HISTORIC AND DESIGN REVIEW COMMISSION

October 02, 2019

HDRC CASE NO: 2019-449
ADDRESS: 519 NOLAN
LEGAL DESCRIPTION: NCB 546 BLK 19 LOT 15 & E 5.58 FT OF 14
ZONING: R-6 ,H
CITY COUNCIL DIST.: 2
DISTRICT: Dignowity Hill Historic District
APPLICANT: Aaron Peterson/PETERSON AARON
OWNER: Aaron Peterson/PETERSON AARON
TYPE OF WORK: New construction
APPLICATION RECEIVED: August 21, 2019
60-DAY REVIEW: October 20, 2019
CASE MANAGER: Edward Hall
REQUEST:

519 Nolan Detached Garage Project:

Proposed location of garage (in yellow)

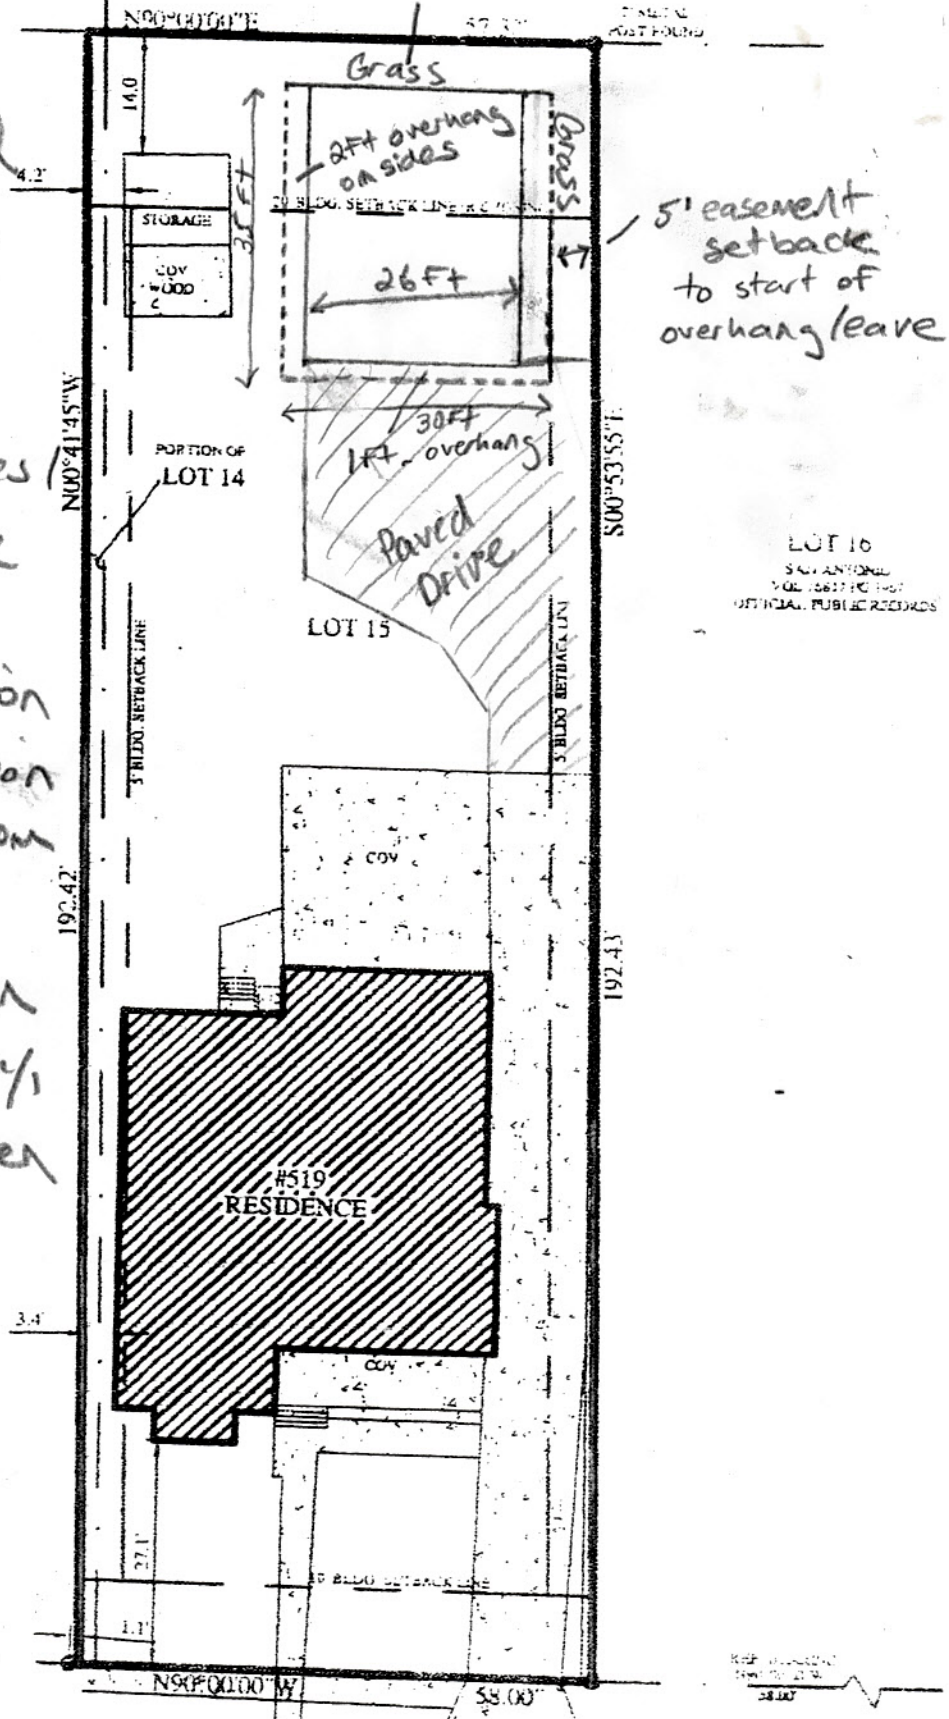
- c. **SETBACKS & ORIENTATION** – The Guidelines for New Construction 5.B. state that the predominant garage orientation found along the block should be matched. Additionally, historic setback patterns of similar structures should be followed. The applicant has proposed to locate the accessory structure at the rear of the property, where accessory structures are historically located within the district. Generally the proposed setbacks and orientation are appropriate and consistent with the Guidelines.

- e. **FOOTPRINT** – As noted in finding a, the applicant has proposed a footprint to feature approximately 900 square feet. The Guidelines for New Construction 5.a.ii. notes that new accessory structures should be no larger in plan than 40 percent of the primary historic structure's footprint. The existing historic structure features a footprint of approximately 1,660 square feet. The total lot size is approximately 11,200 square feet. The proposed footprint is not consistent with the Guidelines as it is more than 40 percent of the primary historic structure's footprint; however, given the overall size of the lot, staff finds that an accessory structure of additional size may be appropriate.
